FLYING HORSE NORTH FILING NO. 3
CONSTRUCTION DOCUMENTS

CONSTRUCTION DOCUMENTS
OVERALL SITE PLAN

PLAN VIEW
POND OUTLET STRUCTURE PLAN
SCALE: 3/4" = 1'

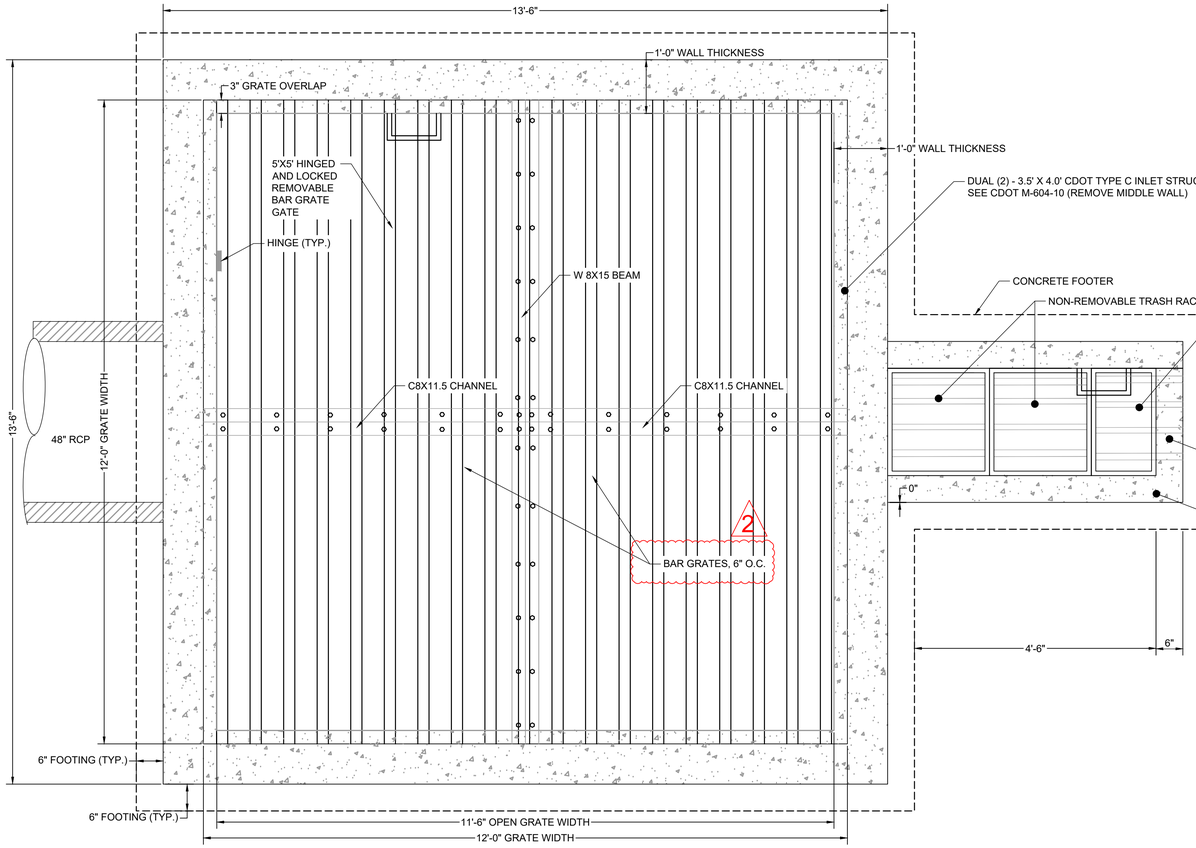
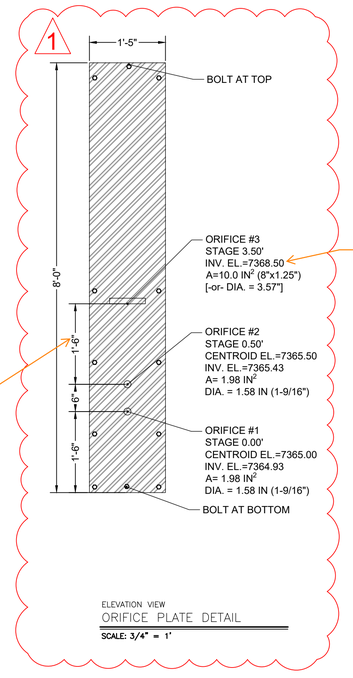
something doesnt seem right here. The Inv Elev of these two holes are ~3ft apart but this dimension only shows 1'-6". Please double check the dim's, elev's, and calcs for these holes

per calcs, this elevation is at the centroid, not inv

ELEVATION VIEW
E REAR FACE
SCALE: 3/4" = 1'

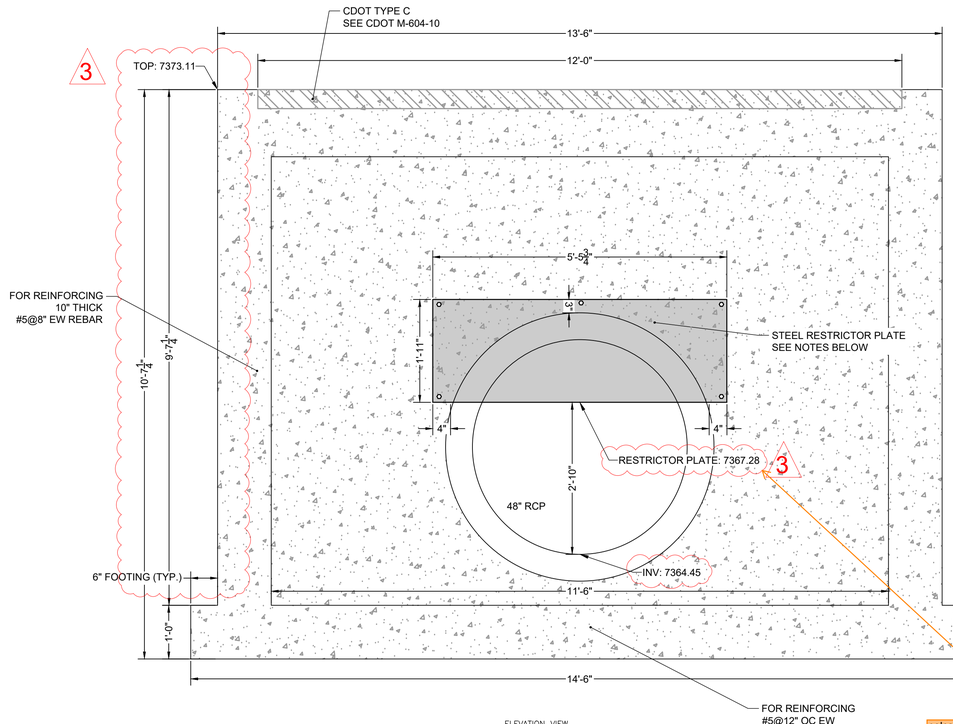
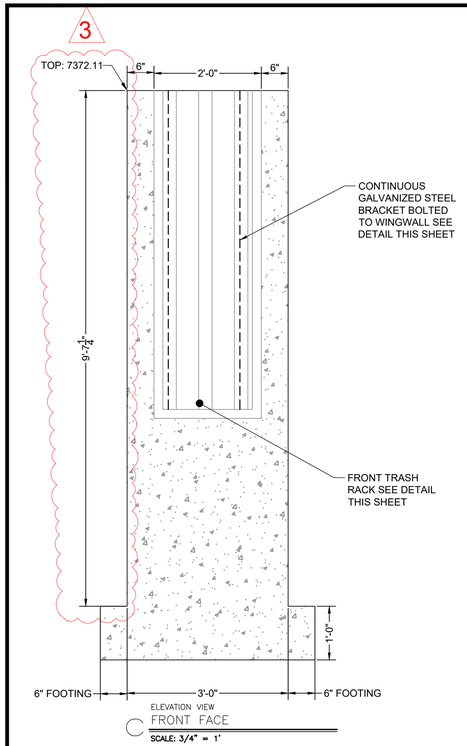
The top of the flat box downstream of the plater is the "Overflow Weir Front Edge Height" input on calcs, not the location you have labeled to the right which is upstream of the plate. Please revise details and calcs accordingly.

calcs show no restrictor plate...

At one point (in June when I was last out there) there was a restrictor plate installed. Did it get removed entirely or moved to a different elevation? Either way, fix the discrepancy between the calcs and this detail.
